City of Franklin

Meeting Agenda

Tuesday, October 10, 2017

JORDAN ROAD PUD SUBDIVISION, DEVELOPMENT PLAN
 RESOLUTION 2017-61
 FRANKLIN MUNICIPAL PLANNING COMMISSION
 8/24/17

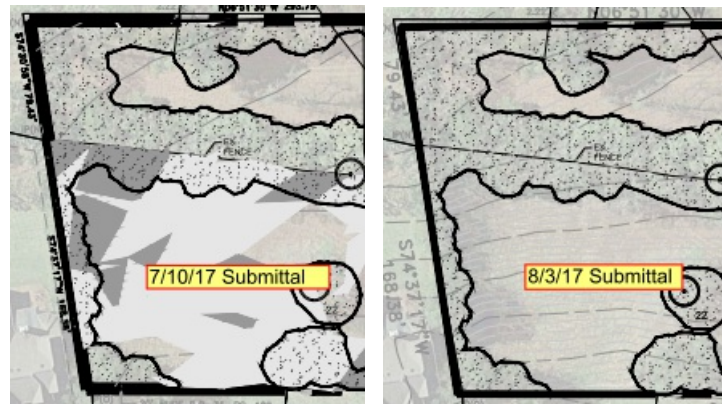
*The following is an Advisory Comment and **does not hinder approval of the Development Plan.***

The storm infrastructure added in Jordan Road does not appear to be positioned to accept offsite flow from the ditch section in the northwest corner of the site. When detailed grading is determined at the Site Plan stage, the storm infrastructure shall be designed and located to accept flow from the upstream ditch section. The headwall shown at the outlet shall be located a minimum of 10 feet from the sanitary sewer manhole, and no portion of the infrastructure shall be located in a stream buffer.

TYPICAL HOME ELEVATION

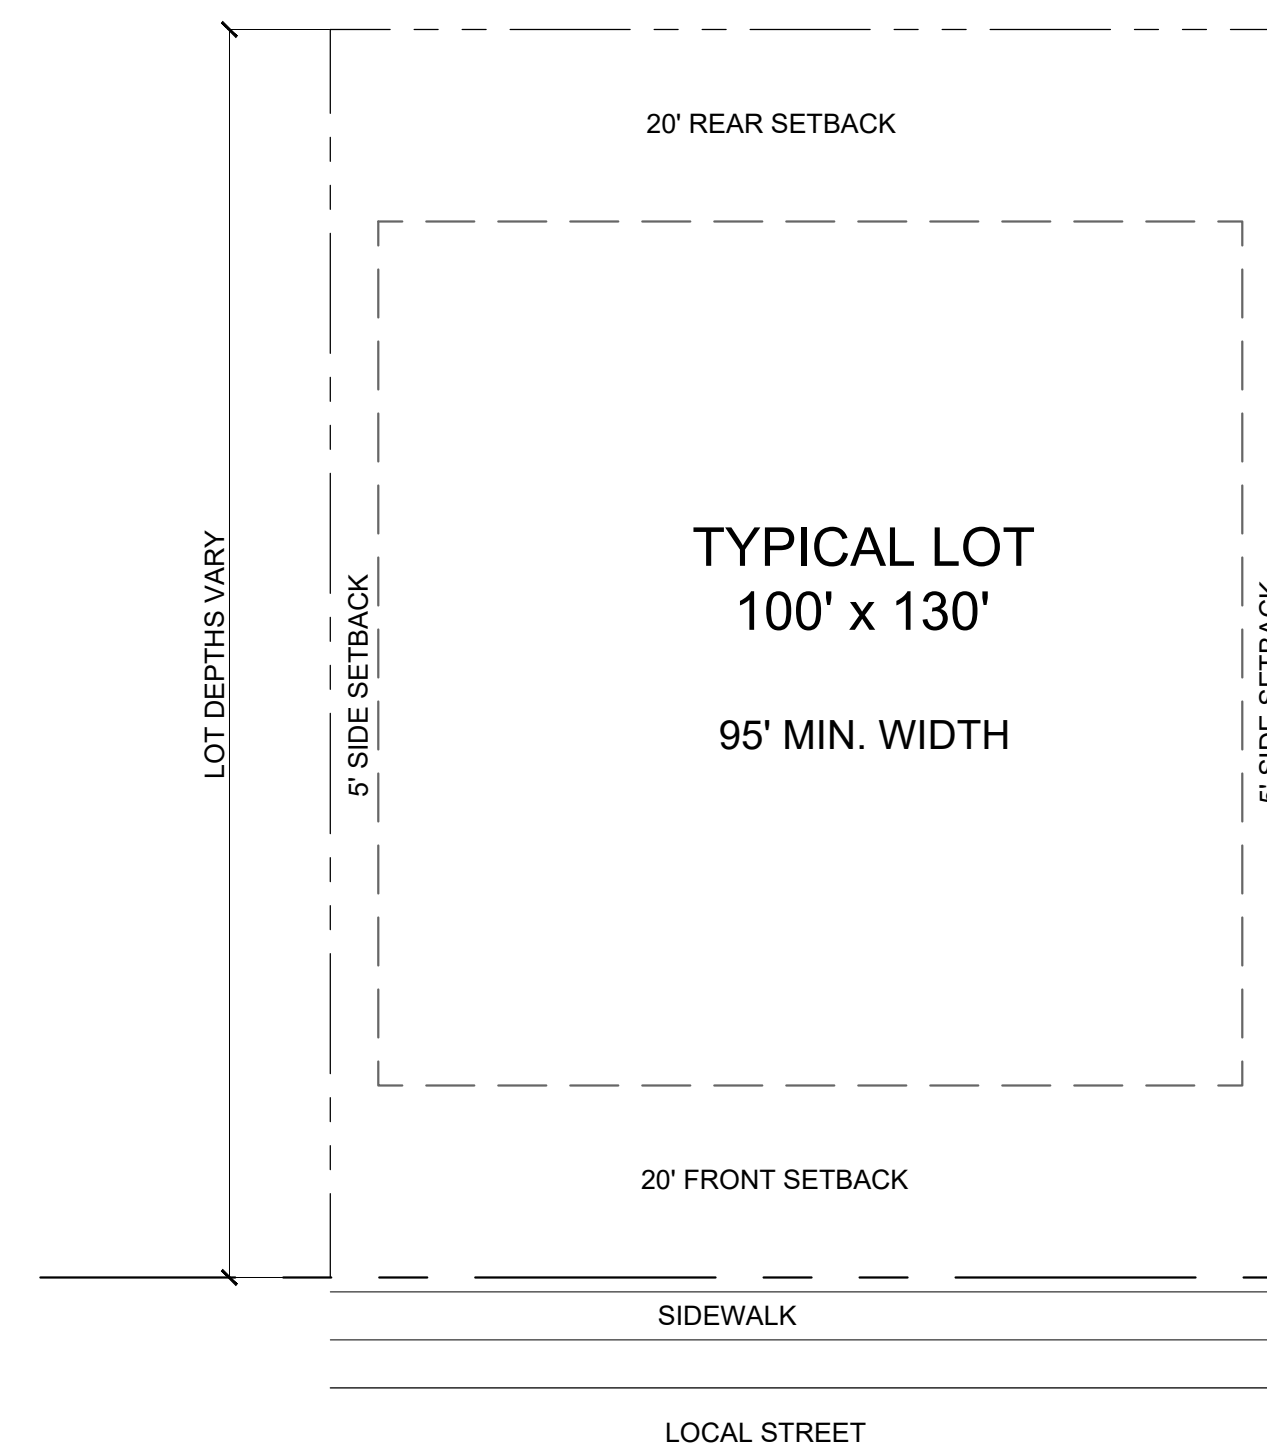
Advisory comment for site plan submittal: Based on the proposed grades shown, it appears that it will be difficult to drain the proposed bioretention area adjacent to Jordan Road. Applicant shall be aware that if bioretention areas are to be utilized as detention areas, the draw down time for bioretention areas is typically between 48 and 72 hours. Be advised that stormwater shall not remain ponded for more than 72 hours in any design storm. Also, if bioretention is to be utilized as detention, the surface area may be increased, but in no case shall the ponding depth be greater than 12 inches.
